UNITED STATES PATENT AND TRADEMARK OFFICE

APPLICATION NO.	FILING DATE	FIRST NAMED INVENTOR	ATTORNEY DOCKET NO.	CONFIRMATION NO.
10/572,378	03/16/2006	Kazuyoshi Koizumi	NIF-107	5660

Office Action Summary	Application No. 10/572,378	Applicant(s) KOIZUMI ET AL.	
	Examiner Mahbubur Rashid	Art Unit 3683

DETAILED ACTION

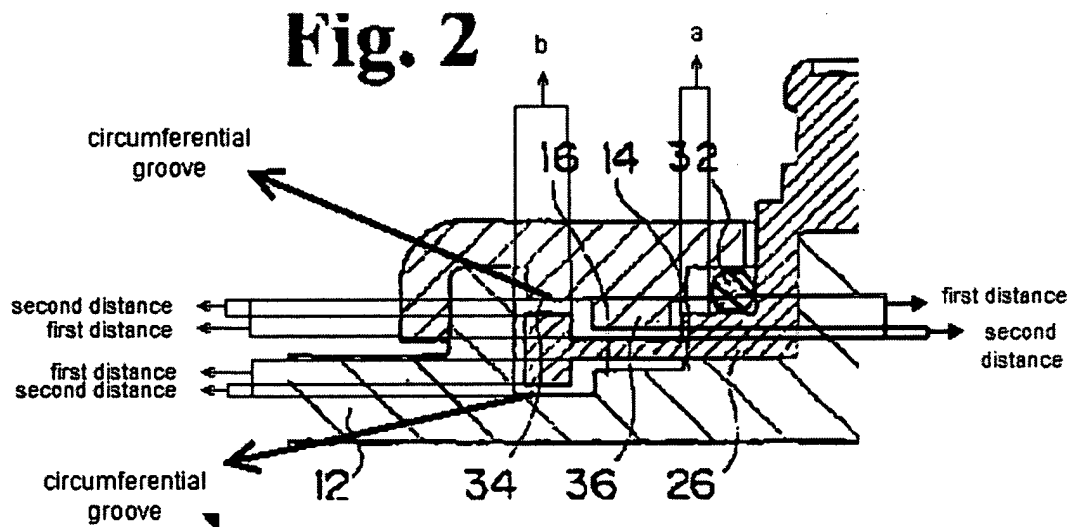
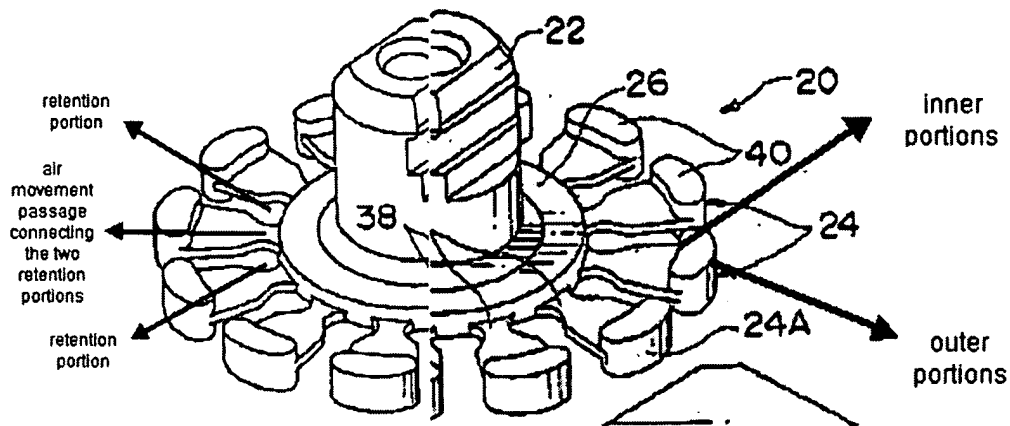
wherein said resistive portion includes multiple air retention portions (the opening between each (24) in fig. 3; see also figure above) provided in a circumferential direction, and air movement passages (fig. 2, (38)) connecting two of the air retention portion retention portions provided in the circumferential direction (see figure above) ,

said housing (fig. 2, (10) and (28)) has an inner surface facing the resistive portion (fig. 2, (24)), A first distance between the air movement passage (fig. 2, (38)) of

the resistive portion and a part of the inner surface directly facing thereto, and a second distance between a portion of the resistive portion radially away from the air movement passage (fig. 2, (38)) and a part of the inner surface directly facing thereto, said second distance being less than the first distance (see figure above).

Re-claim 5, see the radially inner and outer portions (fig. 1; see also the figure above).

Re-claim 7, see a circumferential groove (fig. 2; see also figure above).

wherein said resistive portion includes multiple air retention portions (the opening between each (24) in fig. 3; see also figure above) provided in a circumferential

direction, and said housing (fig. 2, (10) and (28)) includes a circumferential groove (fig. 2; see also figure above) facing the air retention portions (the opening between each (24) in fig. 3) and operating as an air movement passage (fig. 2, see recess at the (24)) connecting two of the air retention portions (see figure above).

Regarding claim 1 on page 7 of the remarks, the applicant argues that Hayashi does not disclose the first distance and the second distance as claimed. The examiner disagrees because the examiner has made the broadest reasonable interpretation of the limitation "a part of the inner surface" to mean that any part of the inner surface of the housing. With this interpretation of the limitation, the examiner submits that Hayashi clearly discloses the first and second distances as claimed (see fig. 2; see also figure above). The examiner notes that the applicant is referring the housing as the reference
